Appl. No. 10/642,313
Reply to Office action of December 17, 2004

Remarks

OBJECTION TO THE DRAWINGS

**FIG. 5****FIG. 6**

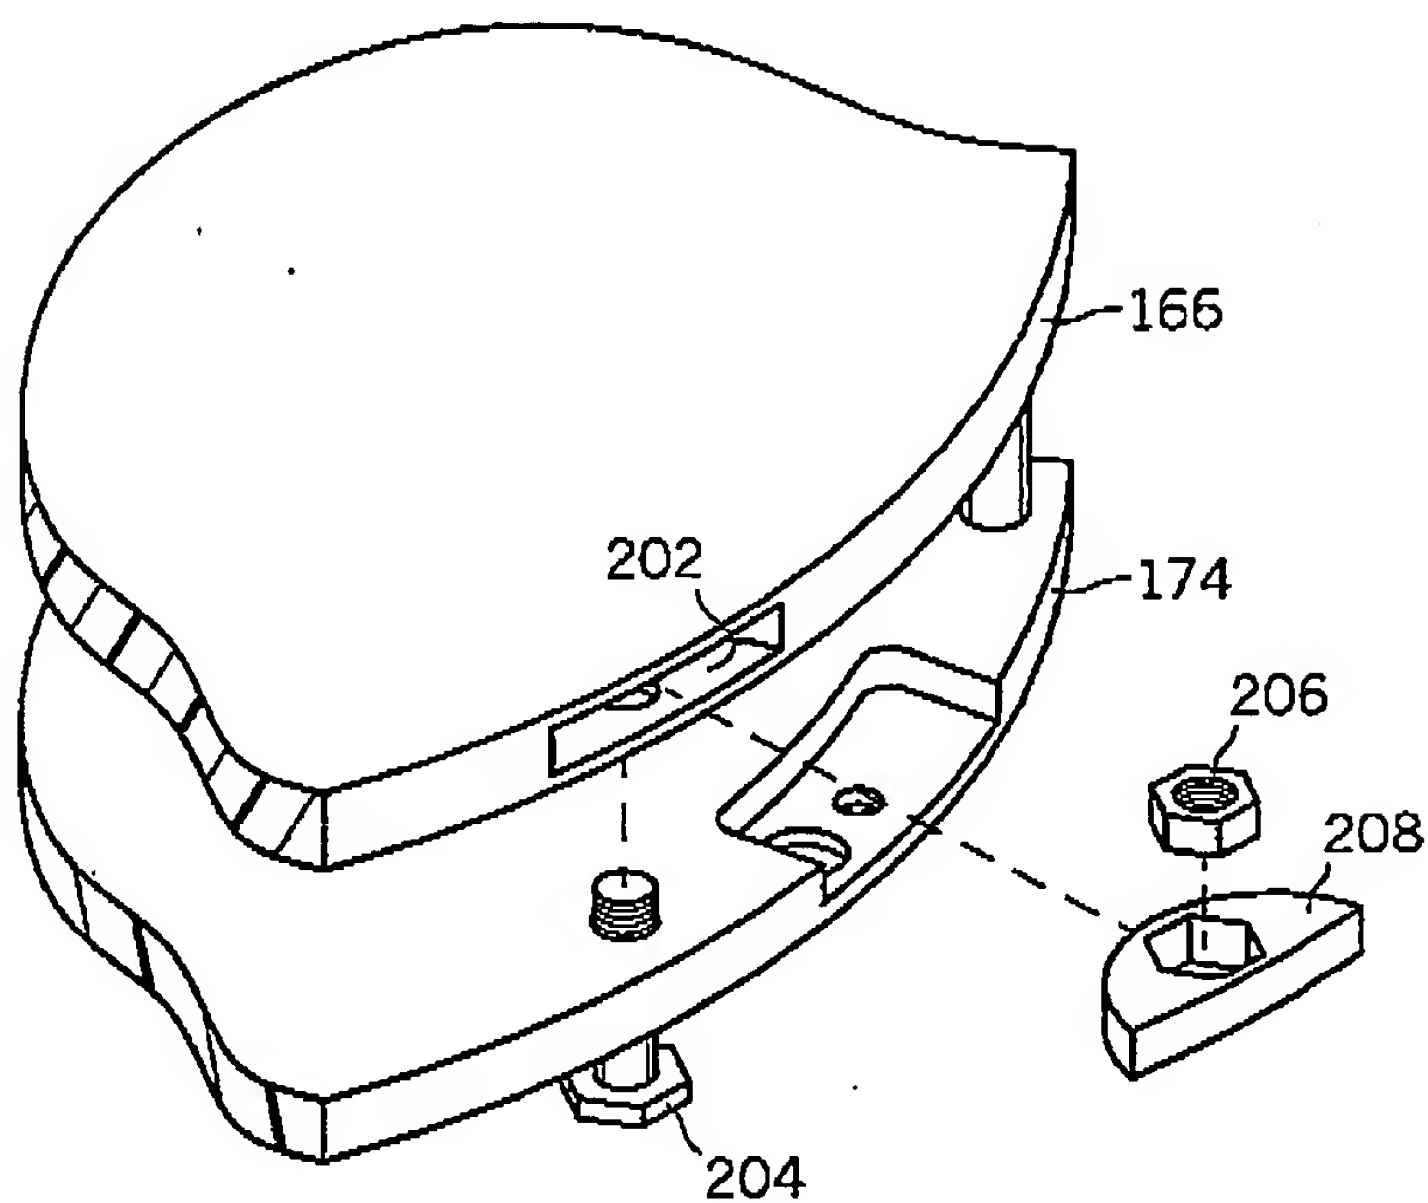
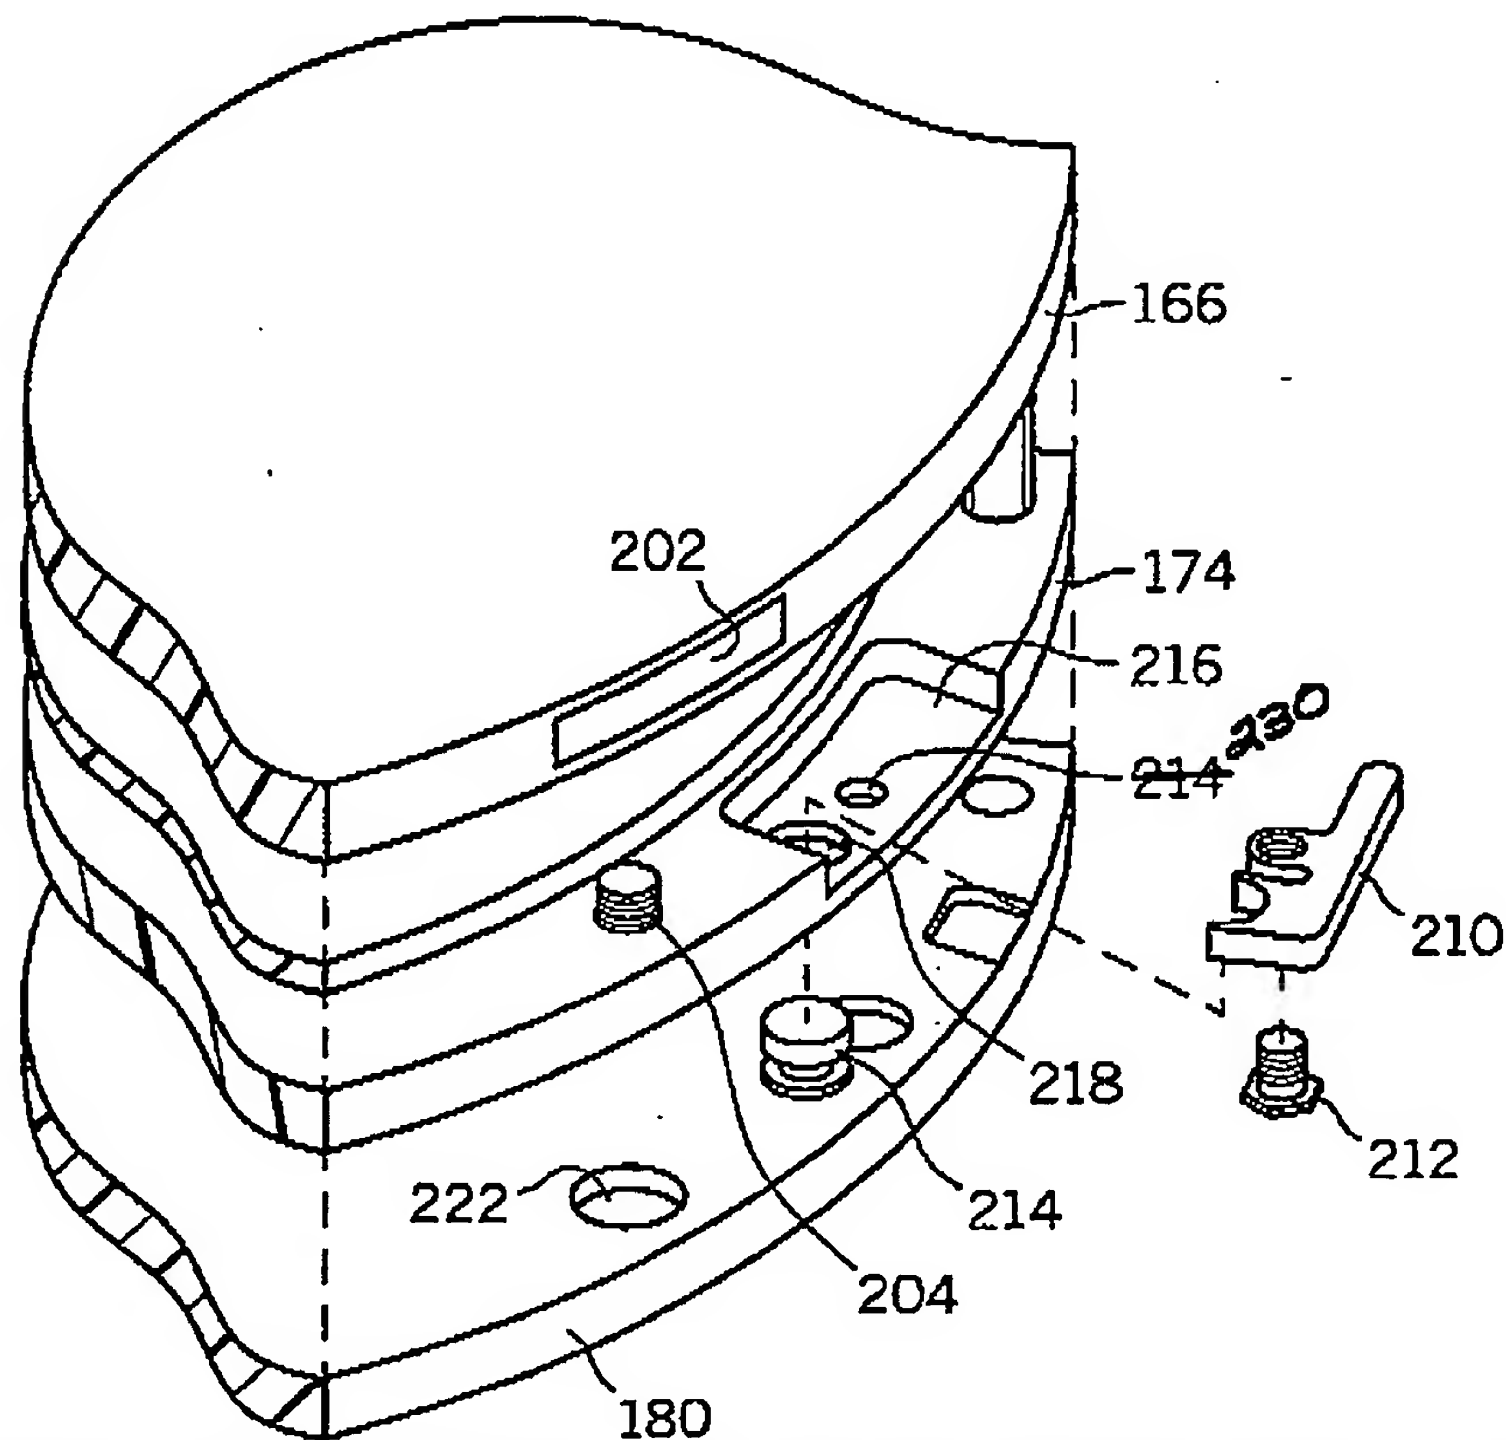
The drawings were objected to for using the same reference numeral to refer to two different elements. FIG. 8 has been amended to assign the number 230 to one of those elements. In reviewing the application, Applicants' attorney noticed that FIG. 6 suffered from the same type of error. Accordingly, FIG. 6 has been amended to apply the reference number 197 to the hollow portion of the light pin. FIG. 2 has also been amended to assign the reference
